# UNITED STATES PATENT AND TRADEMARK OFFICE

APPLICATION NO.	FILING DATE	FIRST NAMED INVENTOR	ATTORNEY DOCKET NO.	CONFIRMATION NO.
09/585,134	06/01/2000	Stephen H. Albertson	TRACKER.001C1	4568

<p align="center"><b>Office Action Summary</b></p>	<b>Application No.</b> 09/585,134	<b>Applicant(s)</b> ALBERTSON ET AL.	
	<b>Examiner</b> Katherine W. Mitchell	<b>Art Unit</b> 3677

**FIG 2**

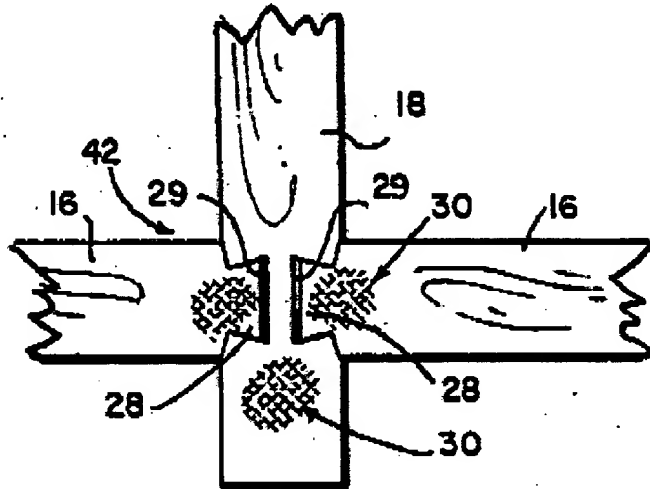
Campbell teaches a building kit, with the interconnecting parts 16/18 both color coded so that they can be correctly matched. Referring to the parts, "18" can be considered the fastener and "16" and "16" considered the connectors preselected to use with a specific fastener. Examiner notes that she is not physically combining the two references, only using Campbell to teach that fasteners and connectors can be color coded to match so that the proper fastener is used with a corresponding connector. The fastener remains the Dickson fastener (nail). Clearly, the color indications "30" of

Campbell are visible from a distance of at least 10 feet by a person with normal vision, as the colors are applied at the ends of structural members clearly larger than the head of a nail, no matter how large the nail, as shown in Fig 2 below.

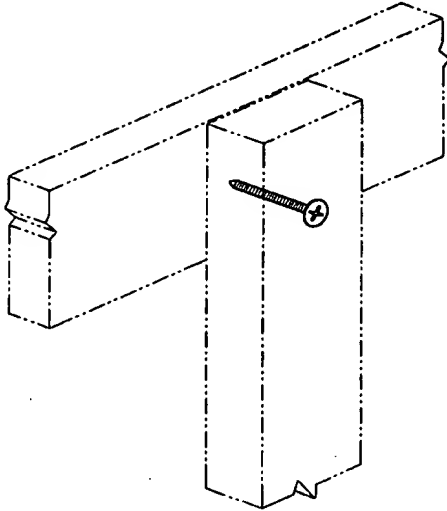
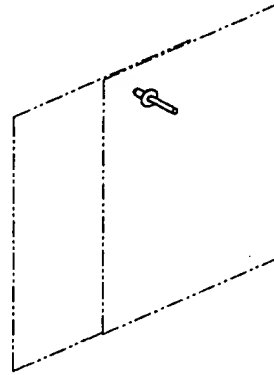
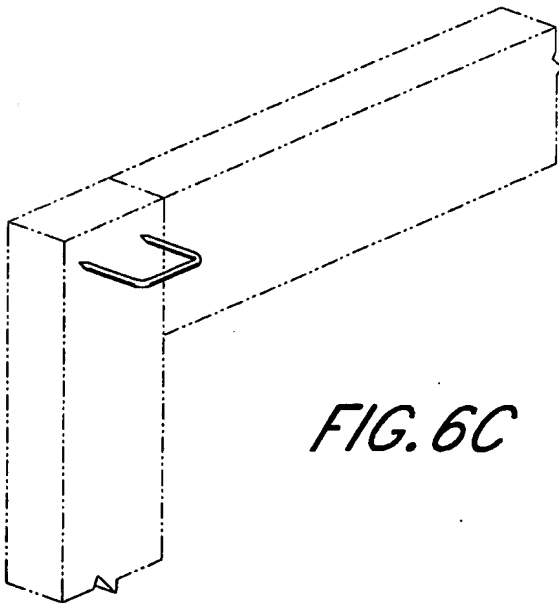
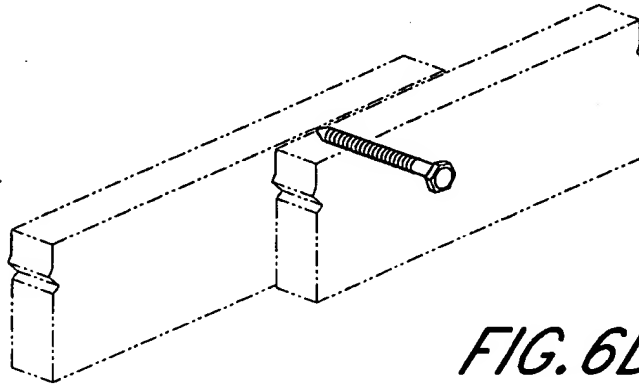
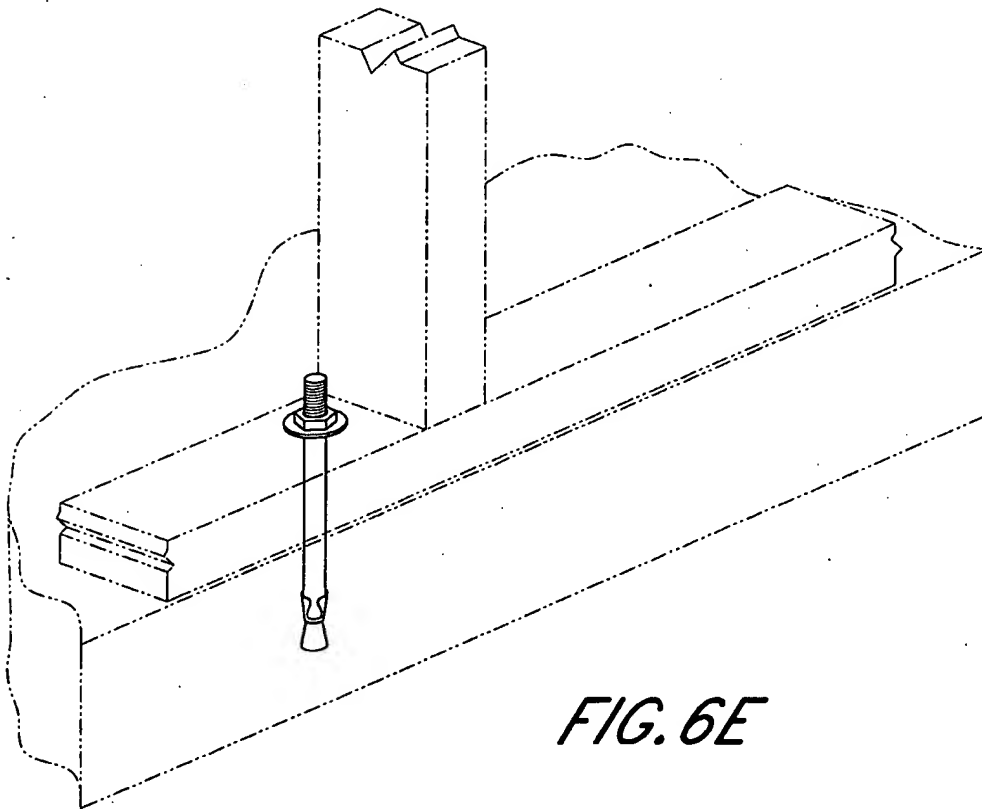
1. Applicant has added to sheets of drawings in response to a drawing objection that certain fasteners were not shown. Examiner agrees that one of ordinary skill in the art would immediately recognize such fasteners, and does not believe any new matter has been introduced in merely showing well-known fasteners in phantom joints; thus the drawings are approved.
